Pre-App – Planning Statement

- Original Planning Application: PA20/06840.
- During construction there were deviations made from the approved planning drawings.
- Planning Application PA23/06724 sought the approval for the deviations.
- The Historic Environment Planning Team objected to the deviations. The full objection can be found within Annexe A. However, these can be summarised below:
 1. Rainwater goods materiality
 2. Roof edge detail
 3. Roof covering fixing methodology
 4. Fenestration materiality

Figure 1 – Rectification Works Overview (scale 1:250)

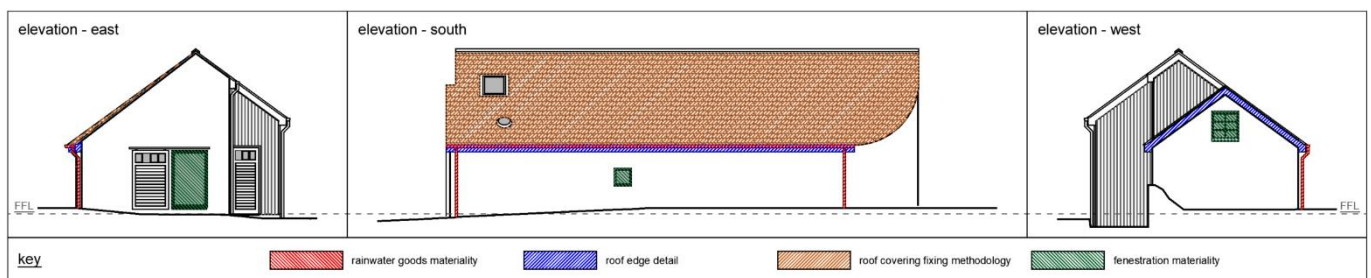
Approved planning application PA20/06840 suggested Alutec rainwater goods. UPVC rainwater goods have been installed which is understood, require replacing. With the understanding that the “curved detailing” is important to the character of the building from a heritage perspective, it is suggested that a ‘Made To Order’ radius gutter from Rainclear is proposed rather than an Alutec system. Reason: The Alutec would need to be a series of straight lengths with bespoke angled joints, whereas the bespoke Rainclear system shall be able to follow the curve of the building.

- East Elevation – A bedded verge on the curved wall has been constructed in line with approval PA20/06840.
- South Elevation – The roof edge detail at the eaves is a deviation to the approval PA20/06840. It is proposed to rectify this detail in line with the recommendations of the HEP Team. It is proposed for the roof edge to follow the curve of the building. We would like to propose a painted hardwood timber fascia board (25mm depth, 200mm height – akin to host dwelling detail) here following the curve of the building. Is this an acceptable detail with the HEP Team? If not, what would the preference be?
- West Elevation – The roof edge detail at the gable is a deviation to the approval PA20/06840. A modern fascia and soffit have been installed; this is proposed to be replaced with painted hardwood timber and reduced in scale.

This aspect of rectification requires substantial work to rectify. Is the replacement of clipped fixings with nail fixings considered an essential requirement to garner support from the HEP Team? To note, the immediate neighbours to the North both include clipped fixings.

There is a single window on each elevation that can be seen from publicly accessible land. It is acknowledged that approval PA20/06840 stated Aluminium and UPVC units have been installed. Do the HEP Team feel that all 3 units require replacement? The windows on the west and south elevation are modest in proportions and on the east, this window is concealed behind an external shutter (shown in Appendix B). To note, the immediate neighbour to the South East of the ‘The Old Post Office’ has UPVC fenestration throughout.
